# Service Bulletin

**Subject:** Exhaust Manifold Heat Shield Modification

**Models:** 2016 Chevrolet Colorado  
2016 GMC Canyon  
Equipped with 2.8L Diesel (RPO LWN)

Heat shield area of concern (1)

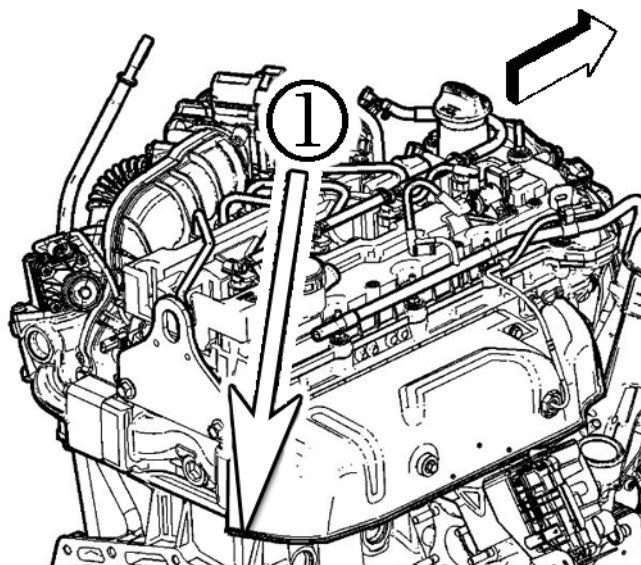
The purpose of this bulletin is to make technicians aware of a condition when installing a new exhaust heat shield on the 2.8L diesel engine. A newly installed, unmodified exhaust heat shield, may come in contact with the wiring harness. These closely routed components could pinch together, and lead to wiring harness damage, abrasion or cuts.

When replacing exhaust heat shield part number 24584464, technicians should modify the shield prior to installation.
